ADDENDUM NO. 3

ROSTER RFSQ NO.: 3907-19-5003
PROJECT NAME: LOWER HILLSIDE (HIGH PARK) WASHROOM
WORK ASSIGNMENT NUMBER: 24-PFR-CAP-GC-003

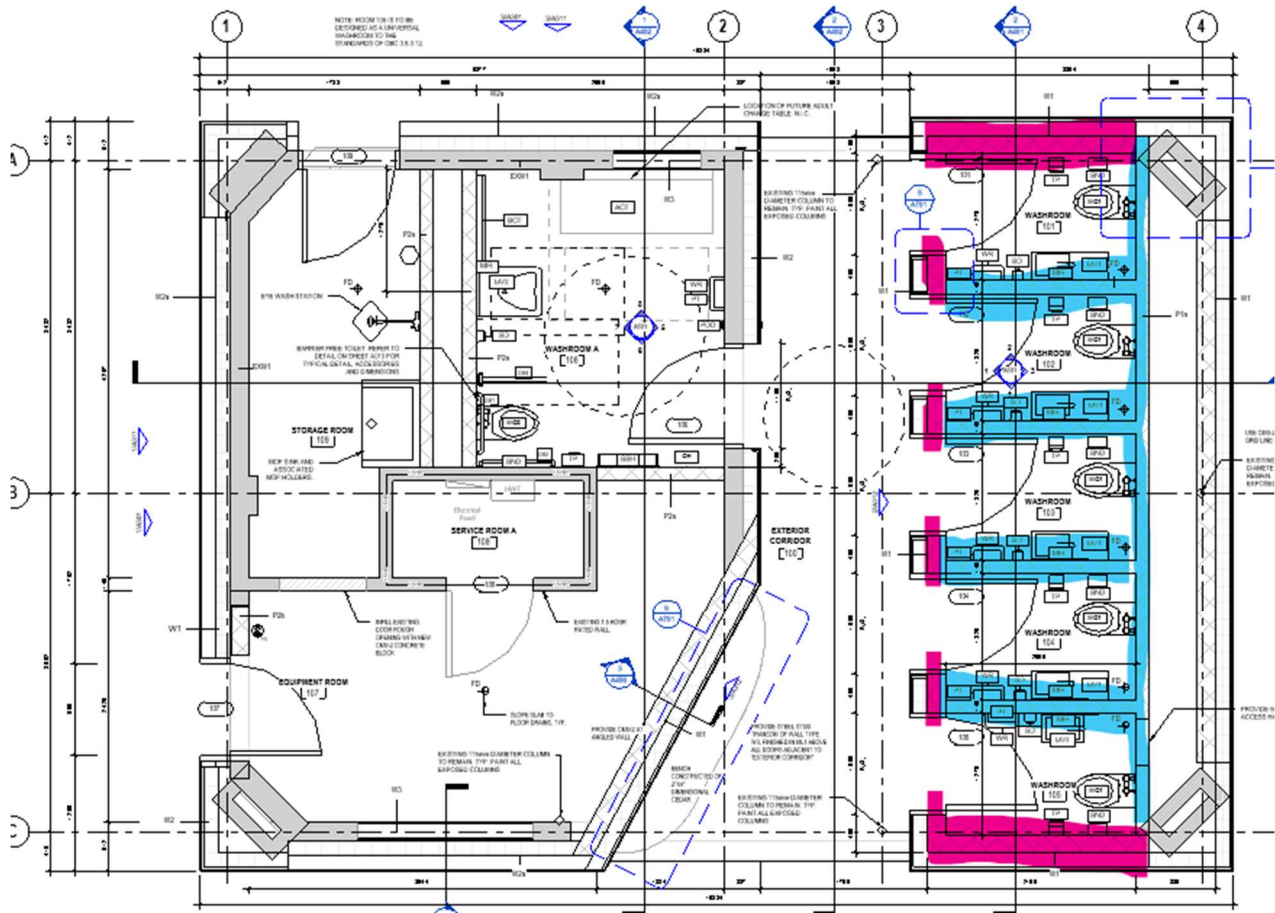
**Q3: Regarding to the specified wall types as per the architectural drawings.
On drawing A211 the Partition Types Schedule
Type P1 is broken down to wall type
P1a -- 140mm x 90mm x 390mm
P1b -- 190mm x 190mm x 390mm**

**Type P2 is broken down to wall type
P2a -- 140mm x 190mm x 390mm and wall type
P2b -- 190mm x190mm x390mm.**

On drawing A501 the interior elevations show the CMU walls to be ashlar height, 90mm high, in a stack bond pattern which is a more costly method of materials and labour.

**Although the floor plan does not designate a P1a type through out as shown on the interior elevations, which method of installation governs?
In addendum No.2 Alternate (Separate) Prices in item 5a, exactly what are they asking for?**

In item 5b they are asking to replace all P1a with P2a as I would understand to replace ashlar height block to full height block, but they must designate the wall types on the floor plan first and not on the interior elevations.

Also they are asking to replace all P1b with P2b but as per the wall types they are exactly the same block type. Please provide clarification for these questions.

A3: Refer to sheet A010. Type P1 is CMU-1 which is Brampton Brick Profile Series. This block is to be installed in a stack bond pattern. All walls adjacent to rooms 101, 102, 103, 104 and 105 to be either P1a or P1b. Also refer to Wall Type W1. Type P2 is CMU-2 which is Brampton Brick CarboClave block. This block is to be installed in a running bond pattern.

In the image below the pink highlighted walls are P1b, while the blue highlighted walls are P1a. All other CMU is P2a or P2b.

No.2 Item 5a in the alternative pricing asks for the price of the CMU-1 as indicated on the drawings, the scope of which is reflected in the image above. Item 5b replaces the ashlar height P1a and the full height P1b in the project with CMU-2.
